CITY OF NEWTON, MASSACHUSETTS

Department of Planning and Development

SUBJECT: #17-10 MICHAEL E. PRATT & TRUDY L. GOOD petition for a SPECIAL PERMIT/SITE PLAN APPROVAL to EXTEND a NONCONFORMING STRUCTURE to add a two-story addition to the rear of an existing single-family residence, increasing the Floor Area Ratio, and to demolish an existing garage and construct a carport on the south side of the lot at 51 HILLSIDE AVENUE, Ward 3, WEST NEWTON, on land known as Sec 32, Blk 3, Lot 5, containing approx 7,160 sf of land in a district zoned SINGLE RESIDENCE 2. Ref: Sec 30-24, 30-23, 30-21(a)(2)b) and 3-21(b) of the City of Newton Rev Zoning Ord, 2007.

Proposed elevations: rear (above) and left side

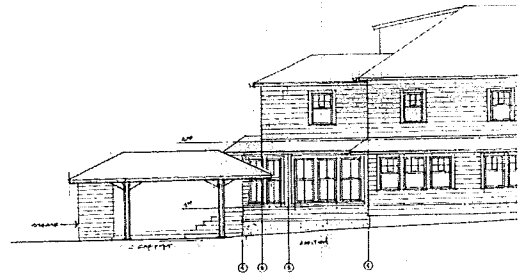
petitioners propose to add a two-story addition to the rear of the house that will increase the floor area of the house from 2,355 square feet to 2,810 square feet, from 0.31 to 0.39 FAR, which is at the high end of the range of floor area ratios for houses in the immediate neighborhood. The addition is designed to be in scale with the residence and with the other structures in the neighborhood. The proposed rear addition and

detached carport both use hipped-roofs so that they mesh stylistically with the existing house and its hipped-roof. Because the

addition is in the rear, it will not be visible from the public street and will have a minimal impact on the neighboring residences.
